SERVICE BULLETIN #125

04/14/14

9660 Spoke Wheel

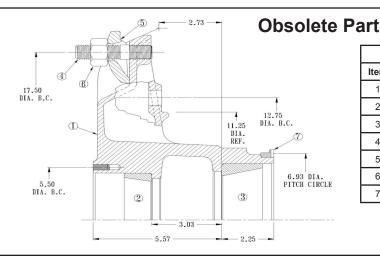
Upon depletion of inventory, the 9660 spoke will become obsolete with no direct replacement. We do however recommend a replacement: the 10-stud 2530 hub. This requires changing brake drums, changing to a disc hub, and changing to disc wheels instead of demountable rims. If you have any questions, please contact the Webb Engineering department via email to engineering@webbwheel.com or call 256-736-6356.

Replacement Option

2530 Bill of Material					
Item	Part No.	Description	Qty		
1	2530T	10 Stud 11.25" Outboard Drive Hub	1		
2	552A	Outer Bearing Cup	1		
3	6420	Inner Bearing Cup	1		
4	51048	ABS Ring	1		
5	Varies	Serrated Stud (M22x1.5 or 3/4-16)	10
